Docket Item # 8
BAR CASE #2009-0116

BAR Meeting
July 8, 2009

ISSUE: Alterations
APPLICANT: Christopher C. and Kay M. Morell
LOCATION: 421 South Columbus Street
ZONE: RB/Residential

Figure 3. Front (east) and rear (west) elevation: proposed alterations.

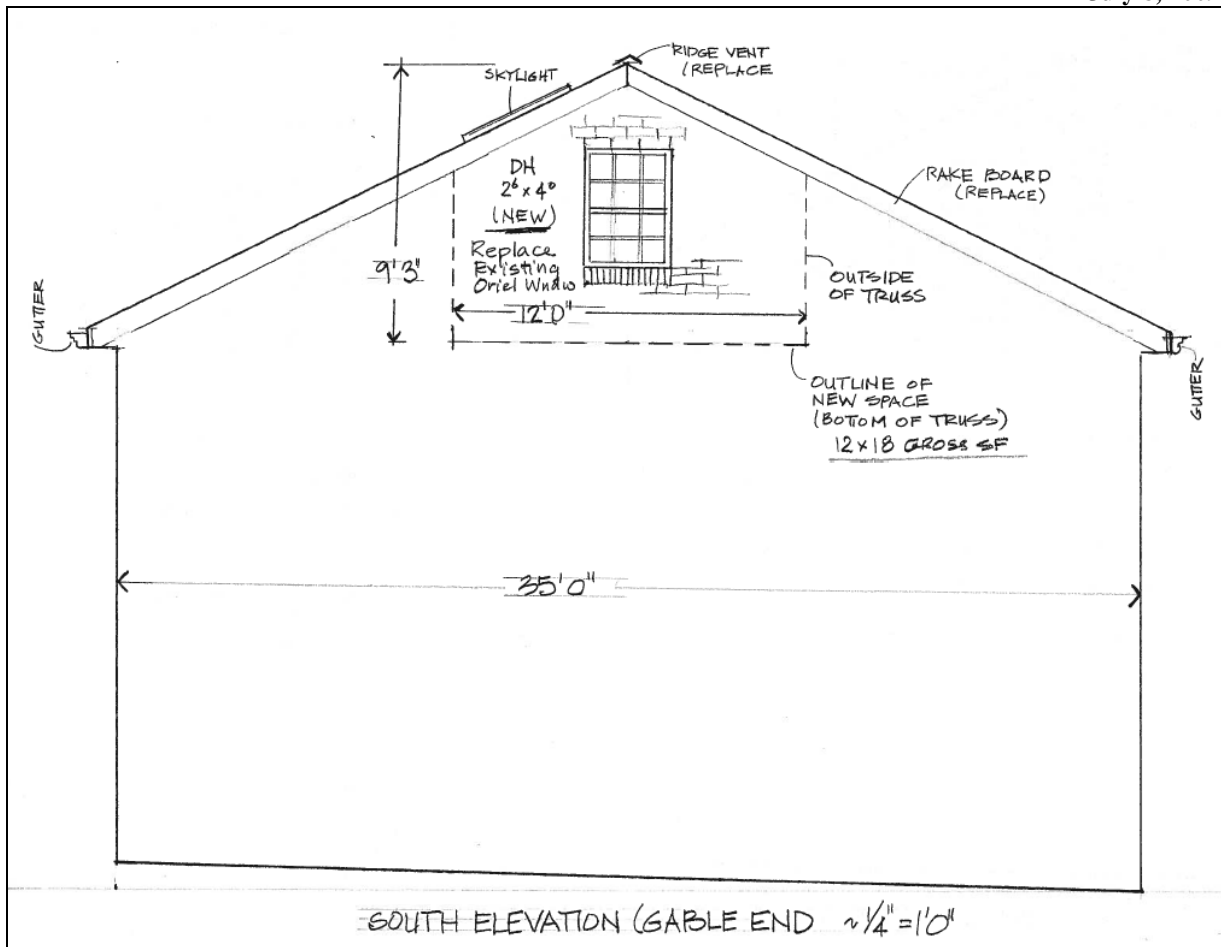
The applicant has indicated that metal six-panel doors were part of the original design for this series of townhouses when constructed. The *Design Guidelines* note that "exterior flush or paneled metal doors are generally not appropriate on residential structures" and that such doors "may be appropriate in certain limited circumstances for 20th century retail, commercial and industrial buildings." Although it is likely that metal doors were part of the original approval for construction, the current *Design Guidelines* discourage that type of door for residential buildings. Furthermore, the Board generally subscribes to a philosophy of material compatibility between historic and non-historic buildings. As Staff generally takes a conservative standpoint, Staff must recommend that the replacement front door be wood. Due to the limited visibility of the rear door behind a 6 foot fence, Staff finds a metal door is acceptable at the rear.

1. That the proposed replacement windows may be double-glazed, simulated divided light with external muntins and an interior spacer bar, but that they be wood instead of aluminum-clad.
2. That the proposed replacement front door be wood instead of metal.
3. That nightshades be installed on the skylights to prevent light seepage.
